TO: Mercedes-Benz Dealer Principals, General Managers, Sales Managers, Service Managers, Parts Managers	FROM: Gregory Gunther, Department Manager, Vehicle Compliance and Analysis, Engineering Services
RE: Recall Campaign 20180600 10 Launch Notification Replace Rear Insulation Mat MY08-09 45 1 (smart fortwo)	DATE: July 20, 2018

Campaign No. 2018060010, July 2018

SUBJECT: **Smart Fortwo Model 451 Model years 2008-2009**
Replace damping in rear engine compartment

Figure 4

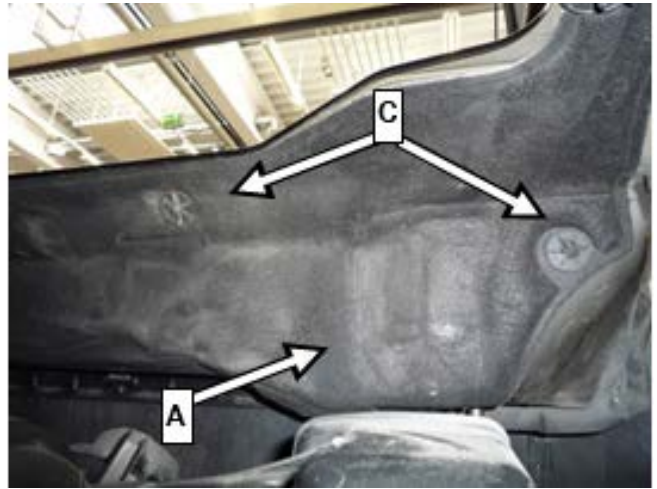
2.2. Remove spring washers (C) for mounting the damping (A) (Figures 4 and 7).
